BLUE BIRD

S16YU

Subject: S16YU, Rear Air Disc Brake Axle Shaft Flange Gasket Replacement
S16YU Replaces S16YN

Models Affected: Model Year: Certain 2015-2017
Model: Vision and All American
School Bus and Non-School Bus

GASKET AND WASHER REPLACEMENT PROCEDURE

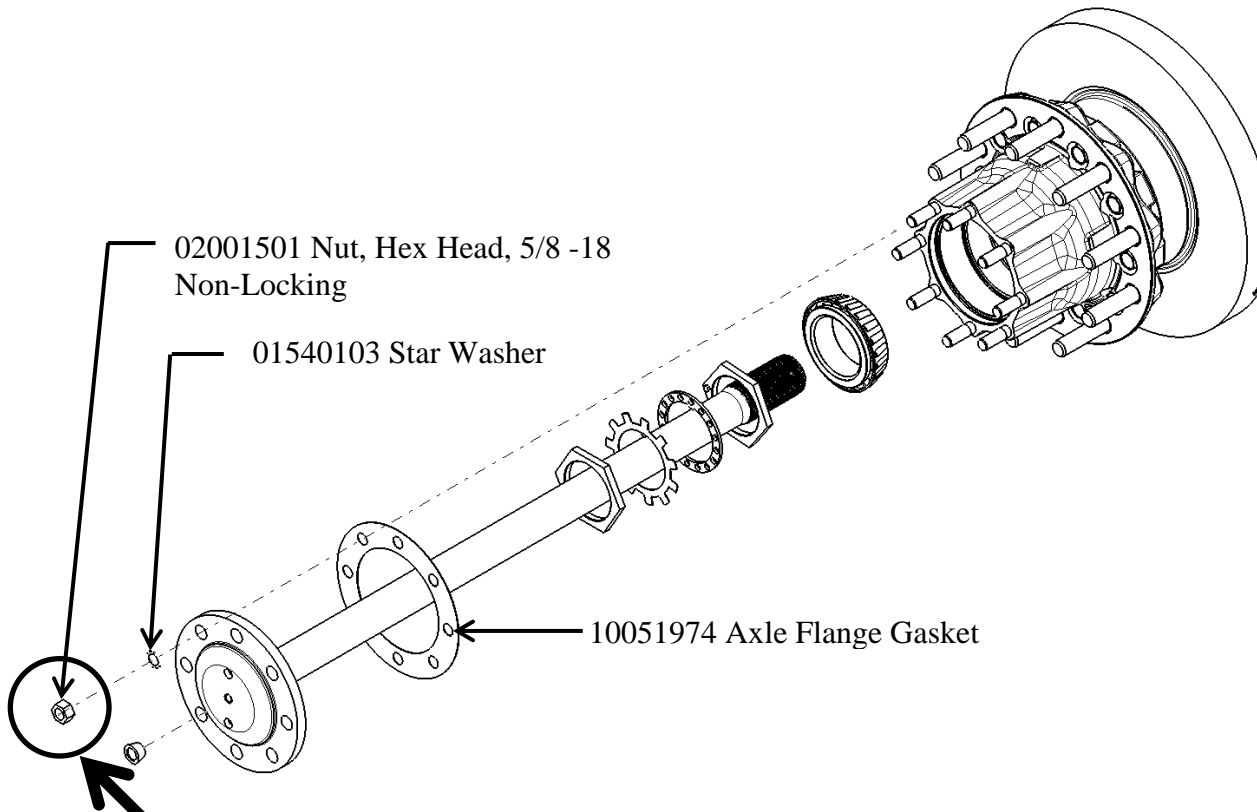
Rear axle shaft flange gasket torque relaxes allowing for possible oil leak between the axle shaft and hub.

Replace the existing rear axle flange gasket with a new gasket and with new star washers. If the original locking nut has not been replaced with a new non-locking nut, replace locking nuts with non-locking nuts.

If there are locknuts on the rear axle studs, remove and discard lock nuts and washers.

1. Park bus on level surface, turn off engine, remove ignition key, and chock wheels.
2. To reduce the possibility of the stud being removed when removing nuts with paint, remove the paint from the existing rear axle shaft flange studs.
3. Remove all (8) eight nuts and star washers on both sides. Replace existing axle flange gasket with new 10051974 gasket on both sides and install axle shaft. If a stud comes out during removal of nut, remove the nut from the stud and reinstall the stud into the hub. Torque stud to 60 to 70 ft-lb.
4. If the bus has the original locknuts, replace with new non-locking nuts. Install eight (8) new star washers 01540103 and eight (8) non-locking nuts 02001501 (removed from axle studs) on both sides.
5. Torque nuts to 60-70 ft-lb.
6. Re-torque all nuts to 170-180 ft-lb. in a “star” pattern.
